AGENDA
BOARD OF PUBLIC WORKS MEETING
Tuesday, April 26, 2022 at 6:00 p.m.
Jackson Municipal Complex
Village Board Room
N168W19851 Main Street
Jackson, WI 53037

PROJECT:
MAPLE FIELDS - PHASE 1
SINGLE FAMILY RESIDENTIAL SUBDIVISION
VILLAGE OF JACKSON, WISCONSIN
BY: NEUMANN DEVELOPMENTS, INC.
N27W24025 PAUL COURT, SUITE 100
PEWAUKEE, WI 53072

C3.4

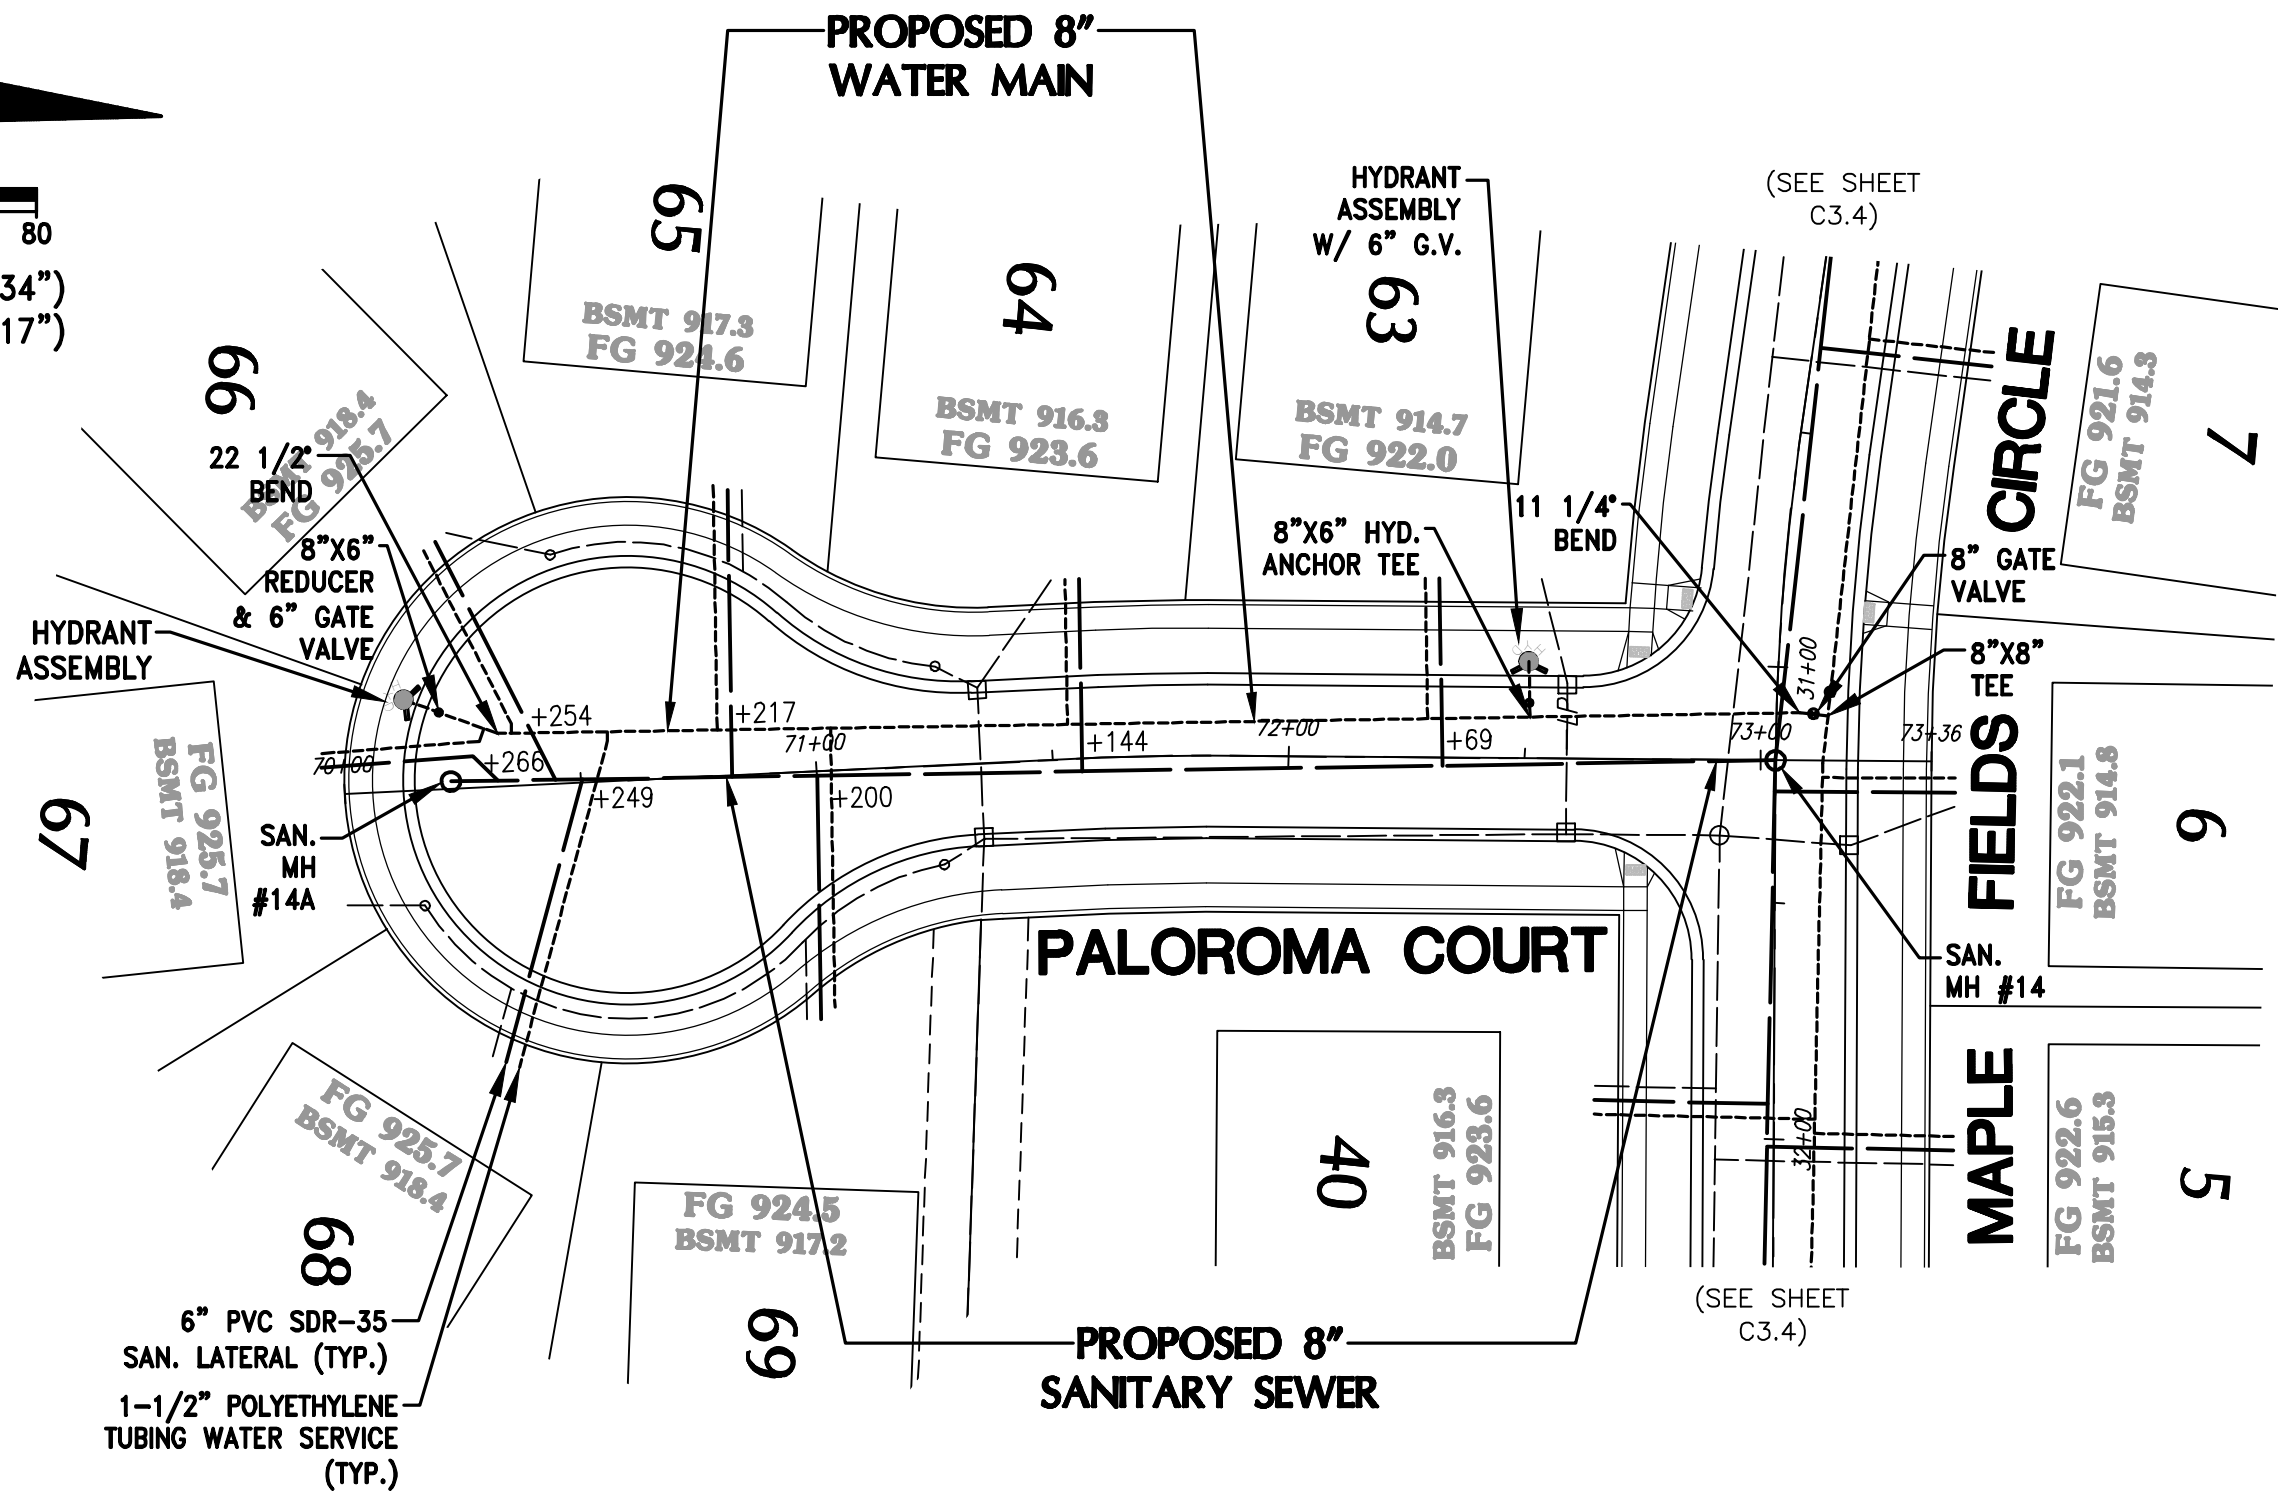
- 14) Sheet Number C3.3 The 8-inch Valve located at Sta 23+40 is not needed and can be removed from the plans.
- 15) Sheet Number C3.4 The hydrant assembly located at Sta 12+45 is not needed and can be removed from the plans. A temporary 2-inch pipe and valve will be needed for flushing the water main during construction.

SHEET
C3.6

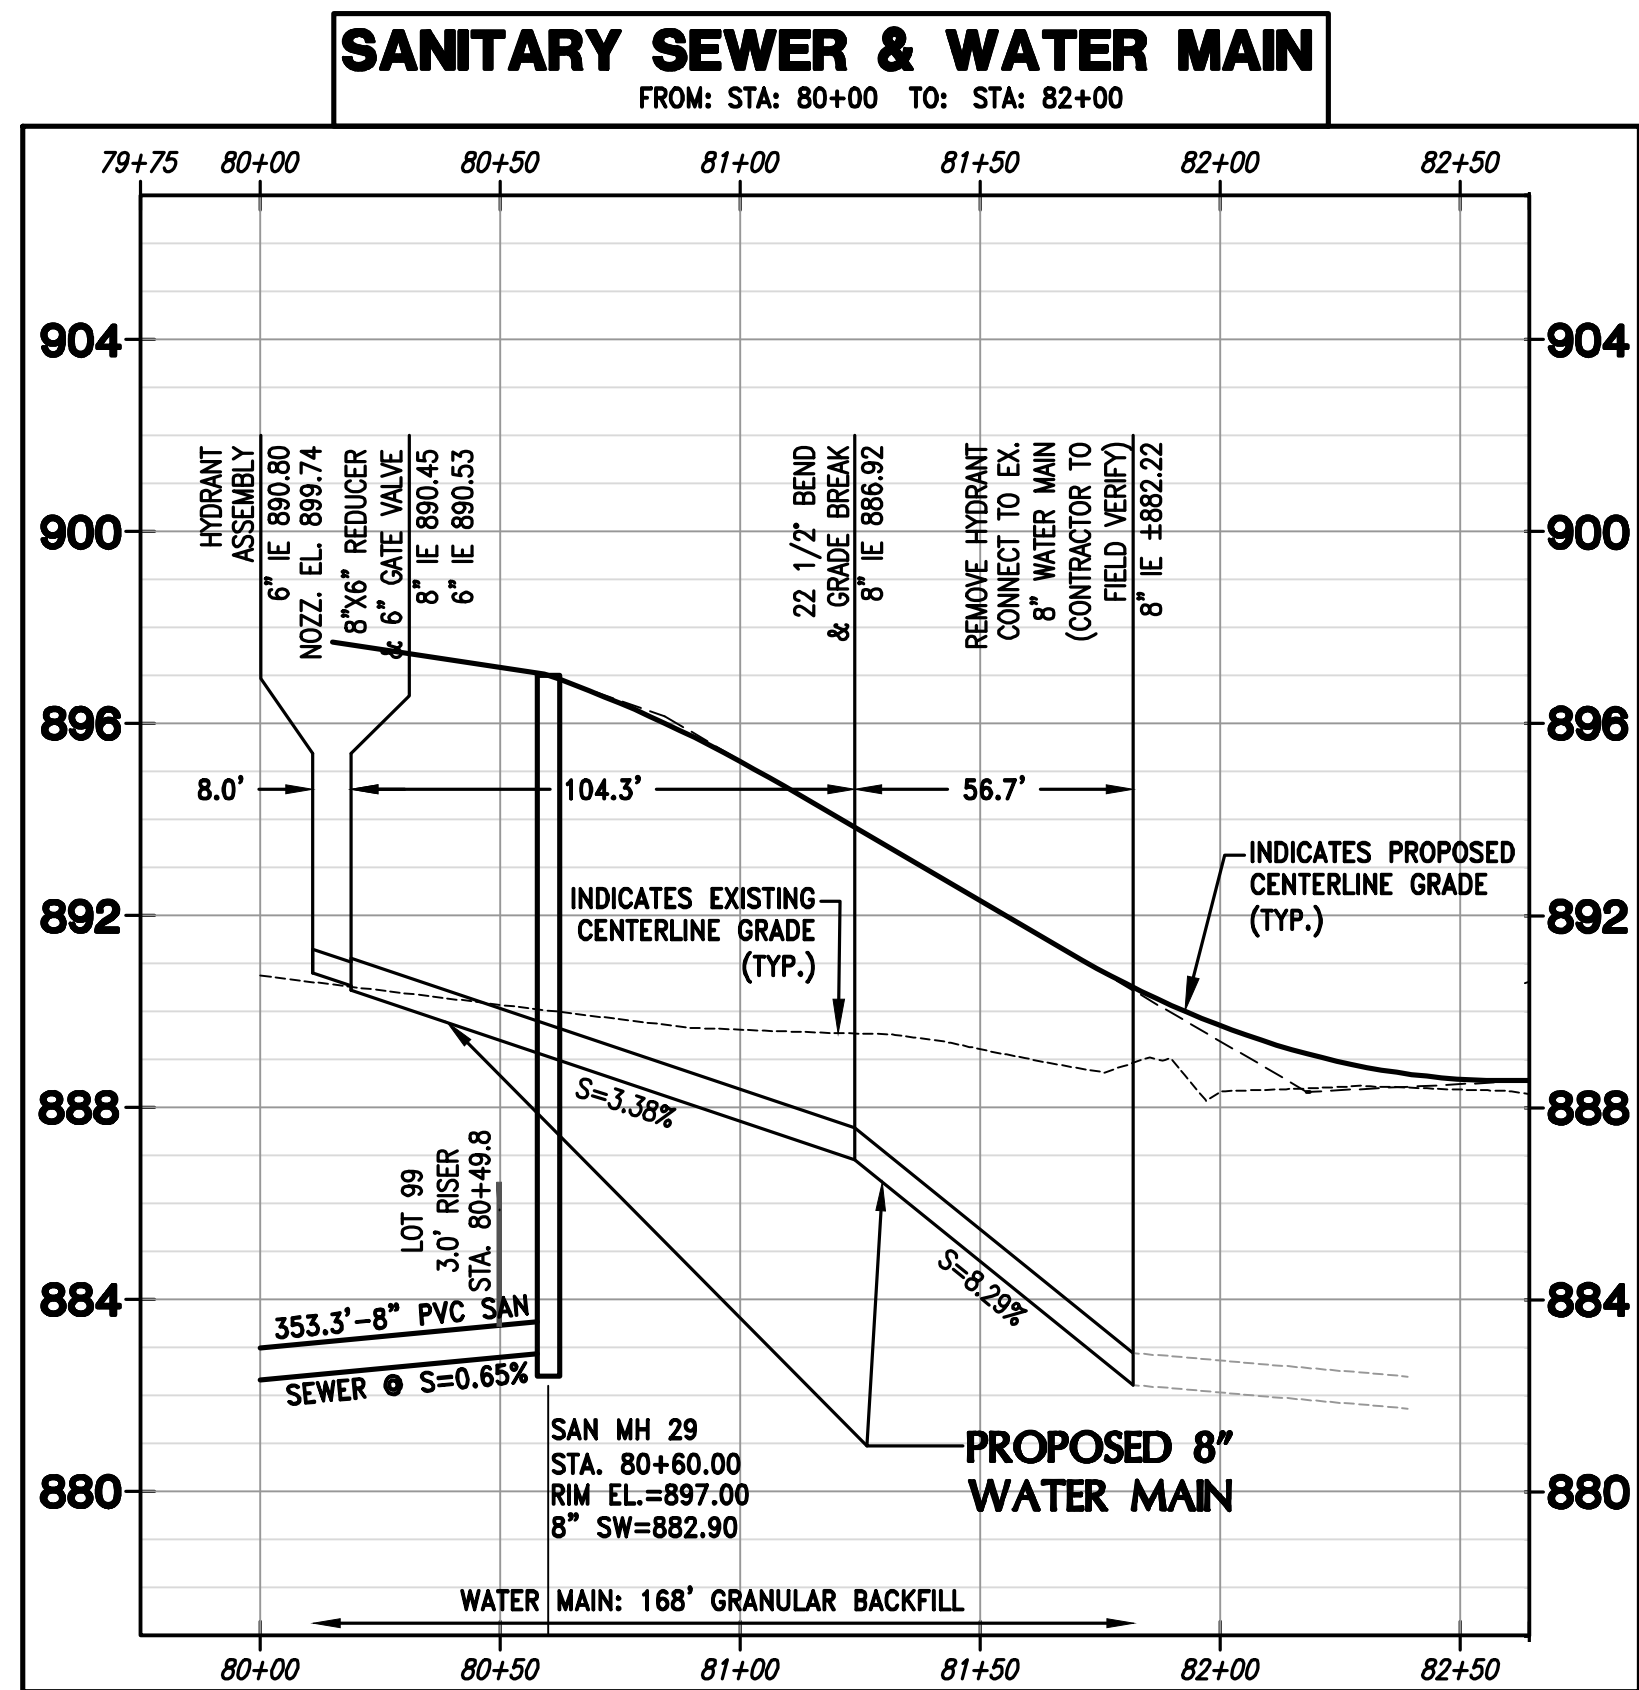
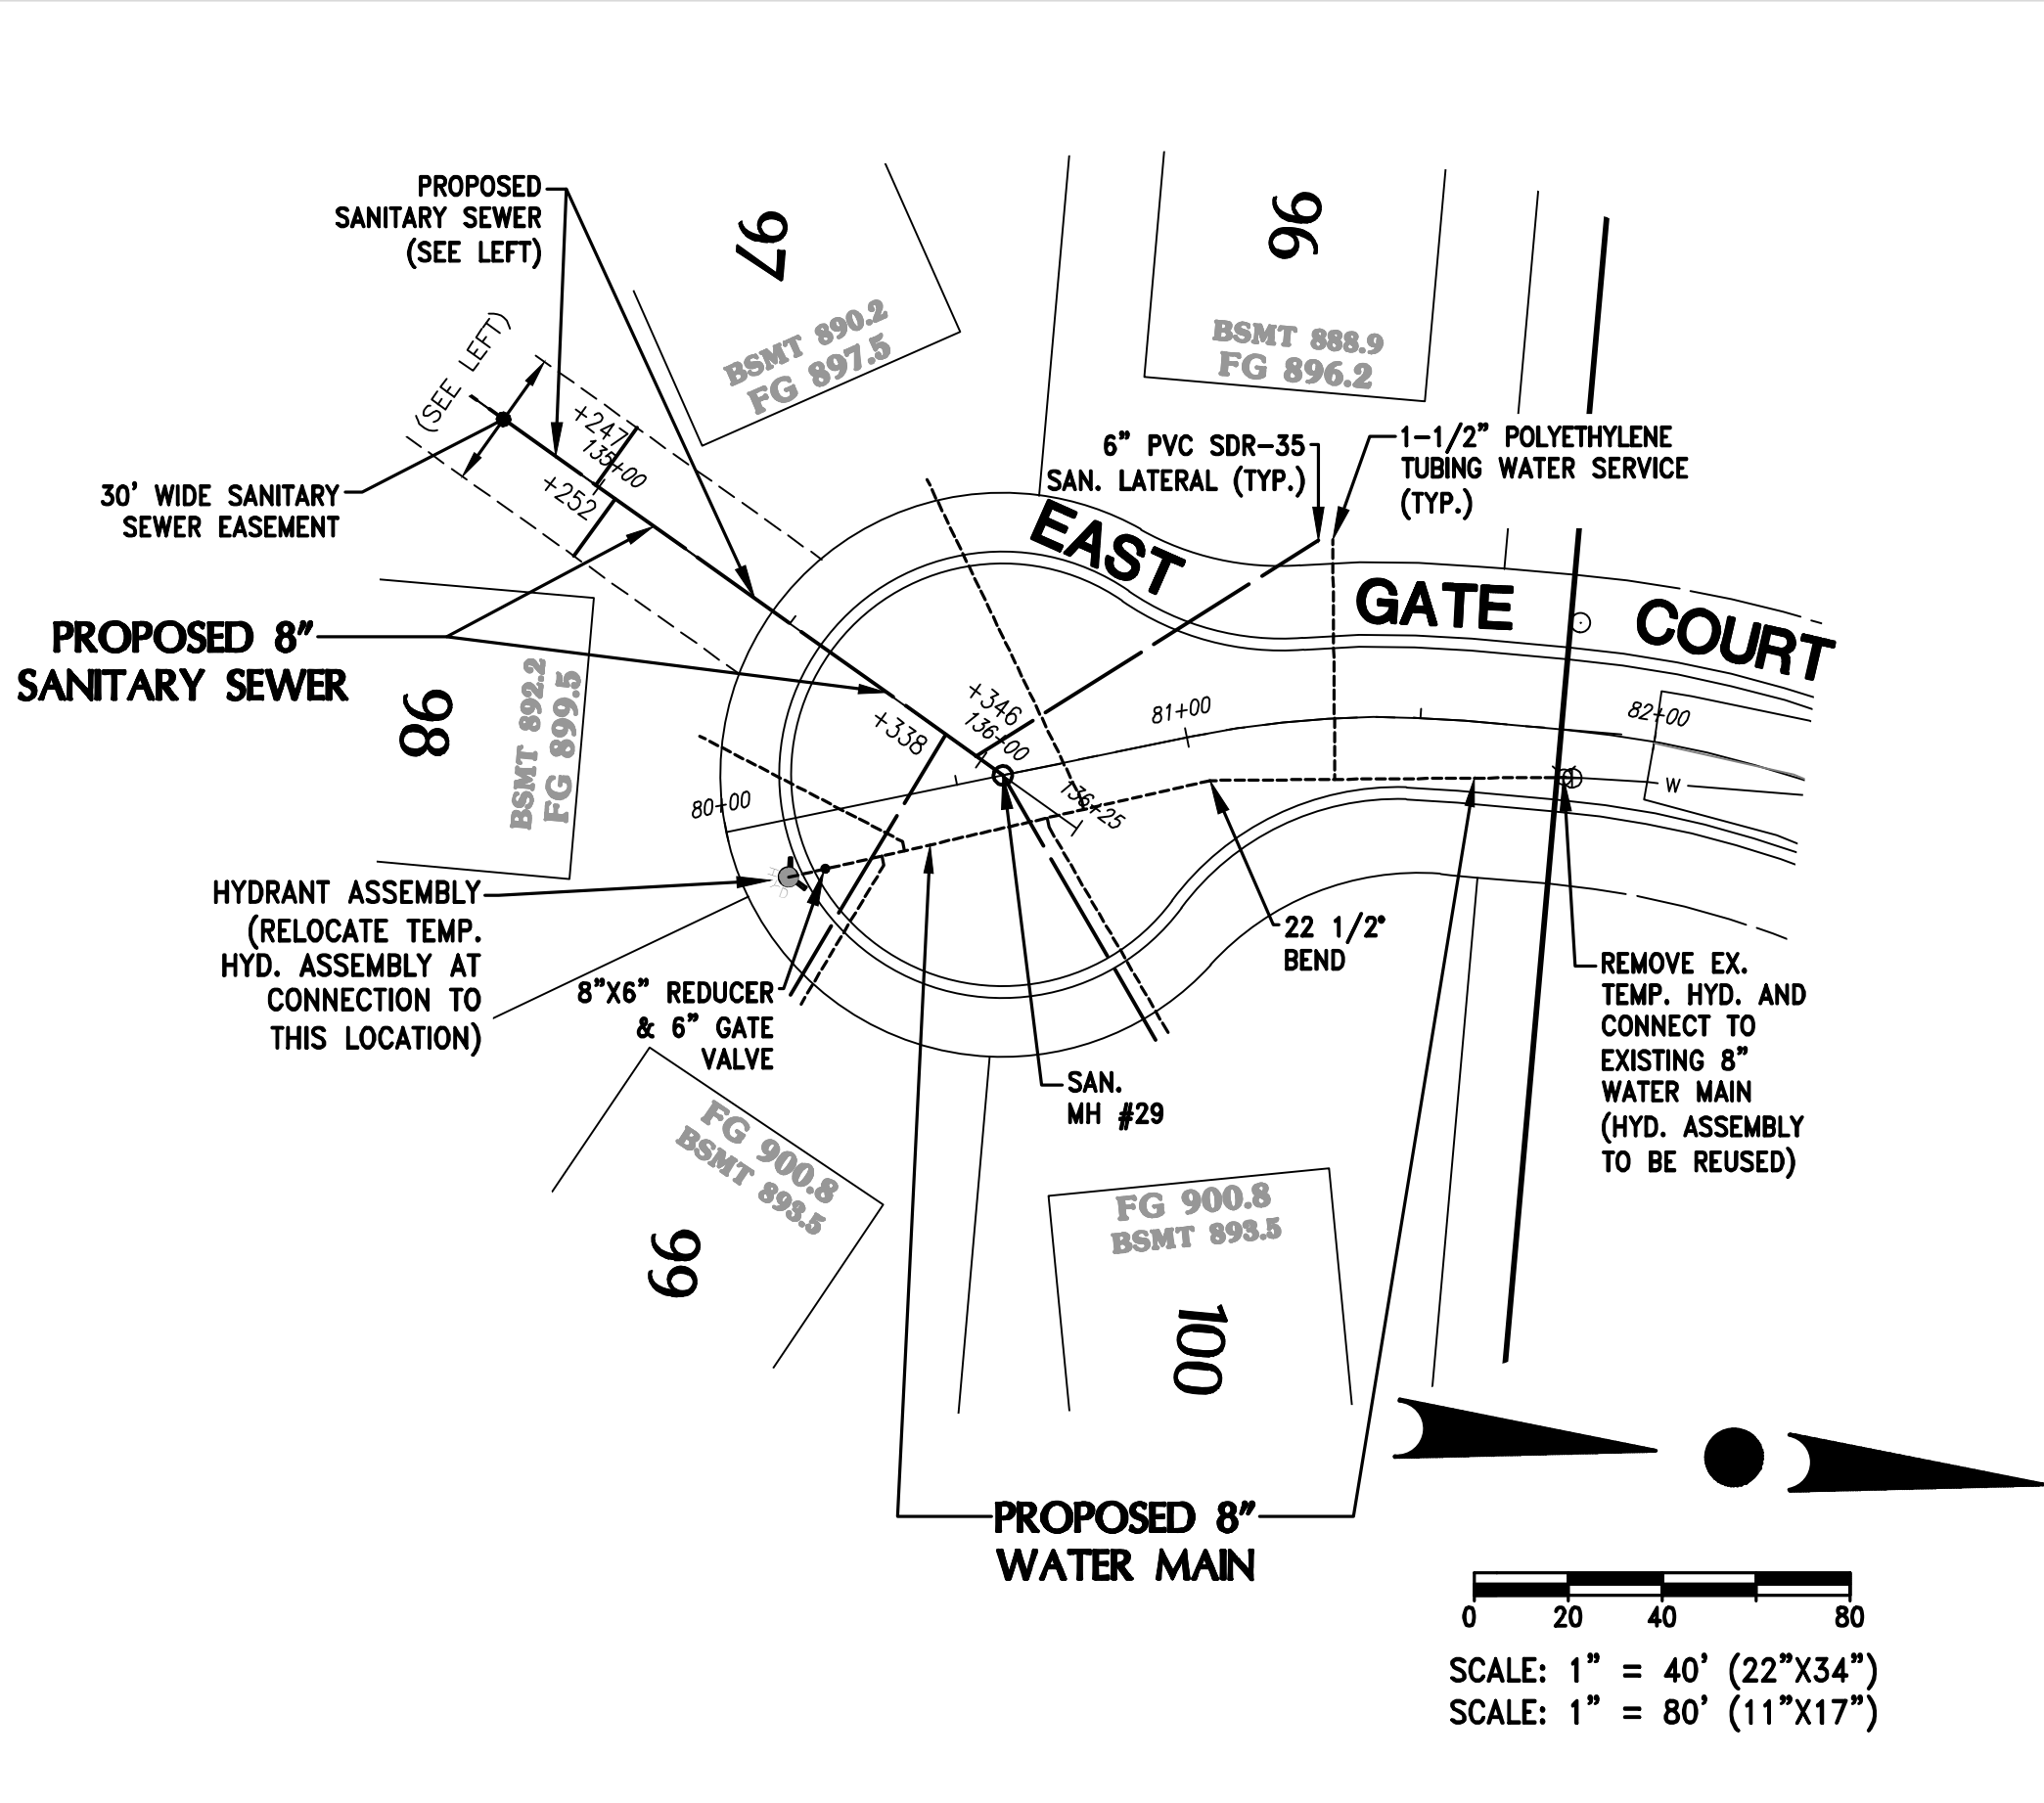
- 16) Sheet Number C3.6 A drivable area over the 8-inch sanitary sewer main serving East Gate Court. Please see culvert comment with sheet number C3.0. A 30 ft easement will need to be continued in Outlot or per the Development Agreement the Jackson Sewer Utility is allowed access in outlot.

- 17) Sheet Number C3.6 No sanitary sewer laterals are allowed to discharge directly into a sanitary sewer manhole.
- 18) Sheet Number C3.6 Reusing existing hydrant shall be inspected by the Jackson Water Utility before reinstallation. No hydrant extensions will be allowed to get to proper height.
